# Access Compliance Report

## Public Rights-of-Way (Curb Ramps)

Intersection ID: 10020684	Main Street: BEAM_RD	Cross Street: N/A	Location: NW
ADA ID: CD4626E1E962	Ramp Type: PerpDiag	Initial Pass/Fail: Fail	Overall Compliance: No
		Severity Score: 25

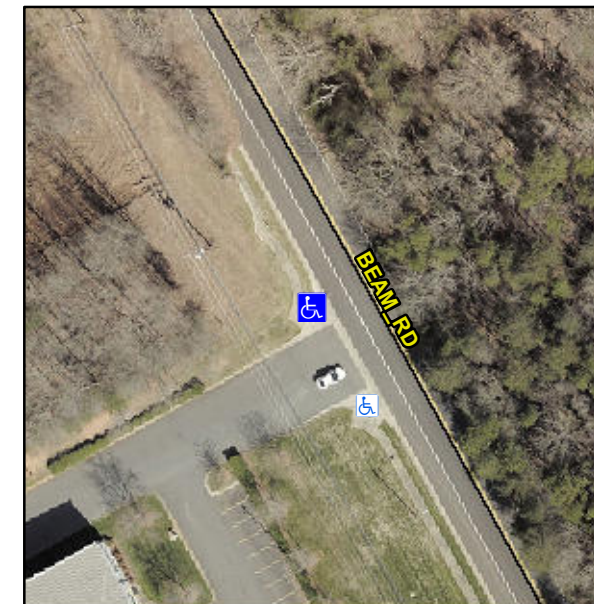
**Not Found, R304.5.3**

Compliance	Description	Data	Compliance	Description	Data
N/A	Ramp Length (in)	120.0	Yes	Ramp Slope (%)	6.9
Yes	Ramp Width (in)	54.0	No	Ramp XSlope (%)	8.4
N/A	Flare Type LT	N/A	N/A	Flare Type RT	N/A
N/A	Flare Slope LT (%)	N/A	N/A	Flare Slope RT (%)	N/A
N/A	Flare Traversable LT?	N/A	N/A	Flare Traversable RT?	N/A
N/A	Landing Length (in)	N/A	N/A	DWS Provided?	N/A
N/A	Landing Width (in)	N/A	N/A	DWS Contrast?	N/A
N/A	Landing Slope (%)	N/A	N/A	DWS Length (in)	N/A
N/A	Landing X Slope (%)	N/A	N/A	DWS Full Width?	N/A
N/A	Landing Curb? (Y/N)	N/A	N/A	DWS Offset (in)	N/A
N/A	Shared Landing?	N/A			
N/A	Gutter Ponding?	N/A	N/A	Gutter Slope (%)	N/A
N/A	Gutter Lip Ht (in)	N/A	N/A	Gutter X Slope (%)	N/A
N/A	Painted X Walk1?	No	N/A	Painted X Walk2?	No
	X Walk 1 Direction	To S		X Walk 2 Direction	To E
N/A	X Walk 1 Width (in)	N/A	N/A	X Walk 2 Width (in)	N/A
	X Walk 1 Slope (%)	0.4		X Walk 2 Slope (%)	1.9
	X Walk 1 X Slope (%)	6.1		X Walk 2 X Slope (%)	3.2

**Remove & Replace Curb Ramp With Two New Directional Ramps or Equivalent.**
